# HISTORIC AND DESIGN REVIEW COMMISSION

**HDRC CASE NO:** 2021-557  
**ADDRESS:** 809 BURLESON ST  
**LEGAL DESCRIPTION:** NCB 1301 BLK 2 LOT 16  
**ZONING:** R-5, H  
**CITY COUNCIL DIST.:** 2  
**DISTRICT:** Dignowity Hill Historic District  
**APPLICANT:** PAUL KURI/IMPERIAL CUSTOM BUILDERS  
**OWNER:** PAUL KURI/IMPERIAL CUSTOM BUILDERS  
**TYPE OF WORK:** Exterior modifications, fenestration modifications, roof replacement and roof form modifications, window replacement, repair and maintenance, column replacement, door replacement, front door removal, construction of a rear addition  
**APPLICATION RECEIVED:** October 28, 2021  
**60-DAY REVIEW:** Not applicable due to City Council Emergency Orders  
**CASE MANAGER:** Edward Hall  
**REQUEST:**

The applicant is requesting a Certificate of Appropriateness for approval to:

1 EXISTING FLOOR PLAN  
SCALE: 1/4" = 1'-0"

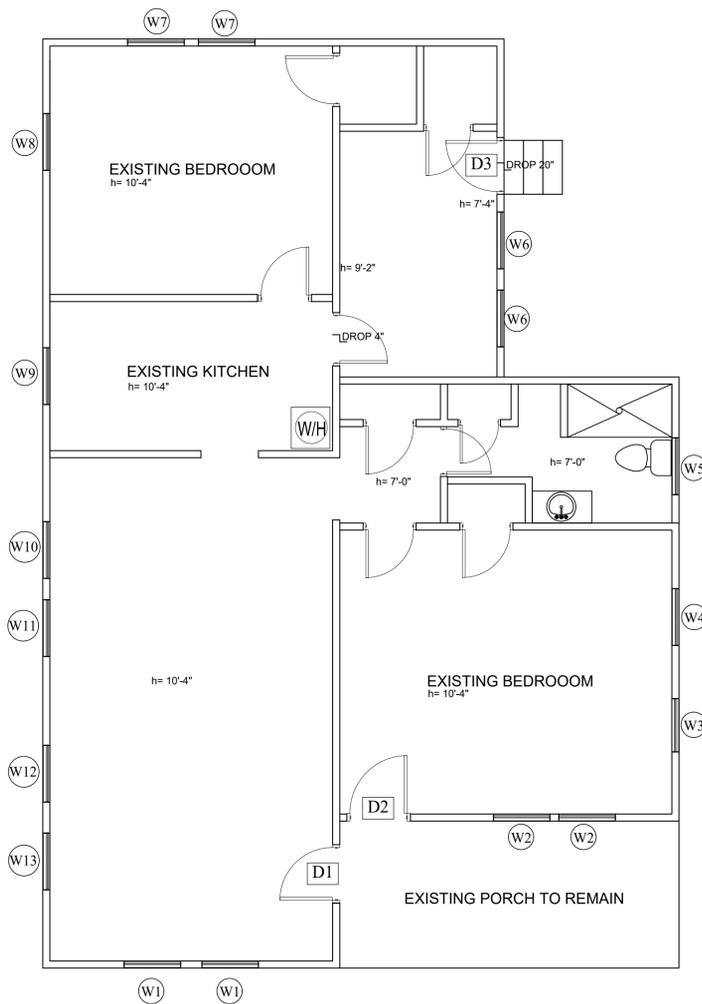
- f. WOOD WINDOW REPLACEMENT – The applicant has proposed to replace the existing wood windows with new wood windows. Staff performed a site visit on November 9, 2021, and found the existing wood windows to be in a repairable condition. The proposed replacement of the existing wood windows is not consistent with the Guidelines for Exterior Maintenance and Alterations 6.A.iii. Staff finds that the existing wood windows should be preserved. Where sashes do not match, the applicant may perform modifications to ensure that sashes match; however, the existing, historic sashes are to be used.

- g. FENESTRATION MODIFICATIONS – The applicant has proposed fenestration modifications including relocating existing openings and enclosing four window openings. The Guidelines for Exterior Maintenance and Alterations 6.A.i. notes that existing window and door openings should be preserved. Staff finds the proposed modifications to be inappropriate and inconsistent with the Guidelines. Staff finds that all existing window openings should be preserved as they currently exist.

- h. WOOD DOOR REPLACEMENT – The applicant has proposed to replace the existing wood doors with new wood doors. The Guidelines for Exterior Maintenance and Alterations 6.A.ii. notes that existing doors should be preserved. Staff finds the proposed door replacement to be inappropriate and inconsistent with the Guidelines. Staff finds that the existing door should be preserved.

5. Staff does not recommend approval of item #5, wood window replacement and fenestration modifications based on findings f and g. Staff recommends that the existing wood windows be preserved and that all original window openings remain as they exist. Non-matching sashes may be relocated to make matching sets.

6. Staff does not recommend approval of item #6, wood door replacement, based on finding h. Staff recommends that all existing, wood doors be preserved.

1 LEFT ELEVATION  
SCALE: 1/4" = 1'-0"

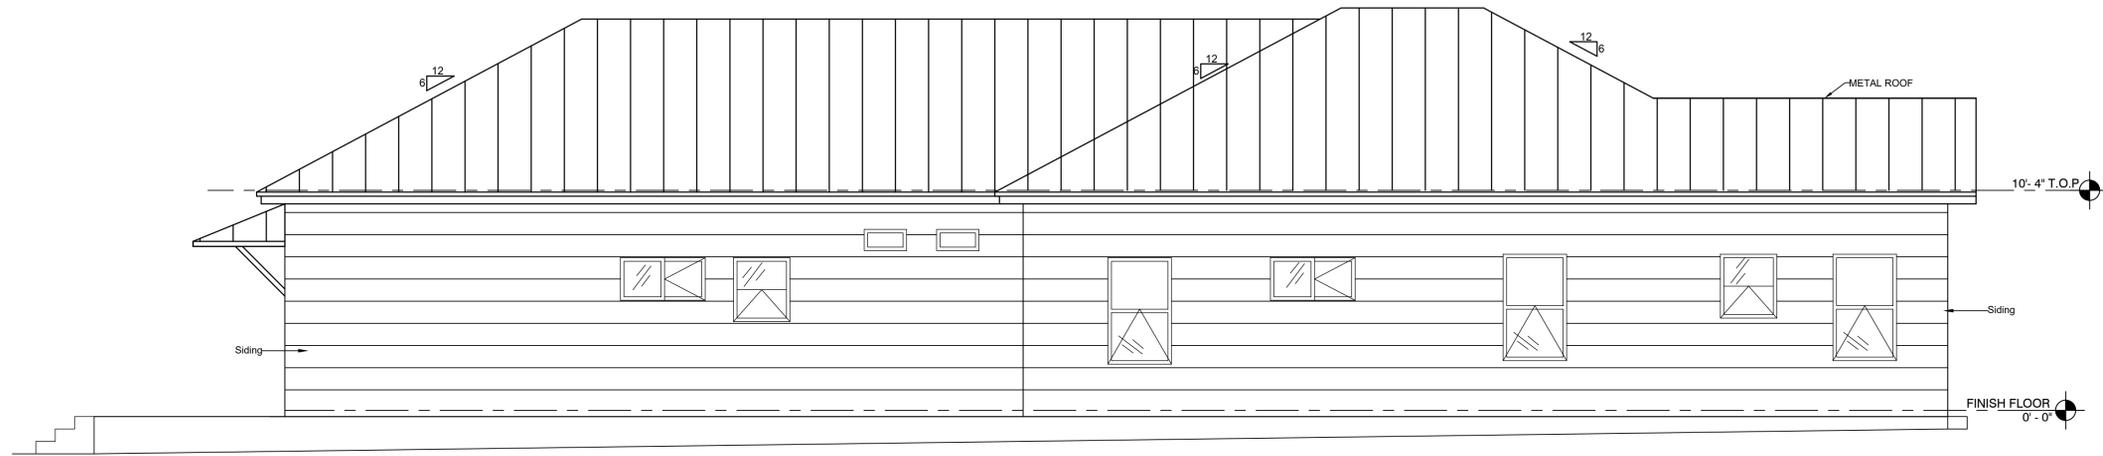
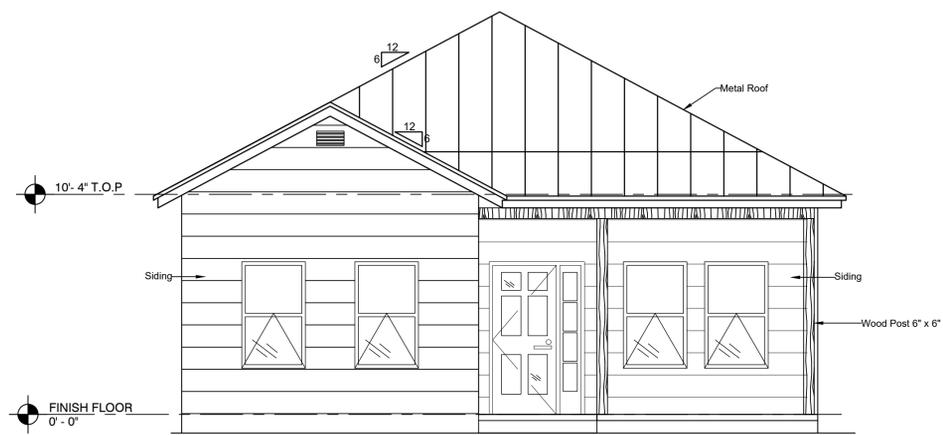
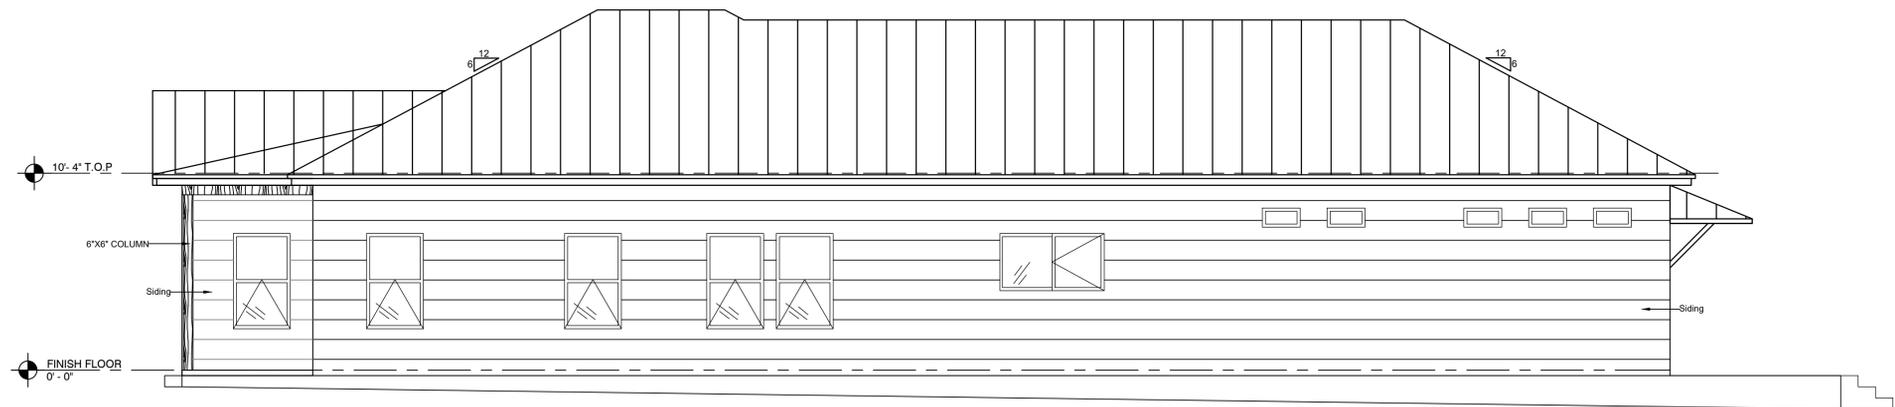
- e. ROOF FORM MODIFICATIONS – The applicant has proposed to modify the existing roof form from a cross gabled roof with both front and side gables to a hipped roof with a front gable. The Guidelines for Exterior Maintenance and Alterations 3.B.ii. notes that the original shape, line, pitch, and overhang of historic roofs should be preserved when replacement is necessary. The proposed roof form modifications are inappropriate and inconsistent with the Guidelines.

- n. REAR ADDITION (Architectural Details) – Generally, staff finds the proposed architectural details of the addition to be inconsistent with the Guidelines. The proposed addition features an overall form and massing that are inconsistent with the Guidelines, a roof form that is inconsistent with the Guidelines, a fenestration profile that is inconsistent with the Guidelines and materials that are inconsistent with the Guidelines. Staff finds that the proposed addition should be redesigned to be in keeping with the Guidelines.

- ii. That the historic roof form is maintained.
4. Staff does not recommend approval of item #4, modifications to the historic roof form, based on finding e. Staff recommends the historic roof form and profile be maintained as they exist.

9. Staff does not recommend approval of item #9, the construction of a rear addition based on findings k through n. Staff recommends that the addition feature a footprint, massing, roof form, materials and architectural details, including fenestration profiles that are consistent with the Guidelines for Additions.
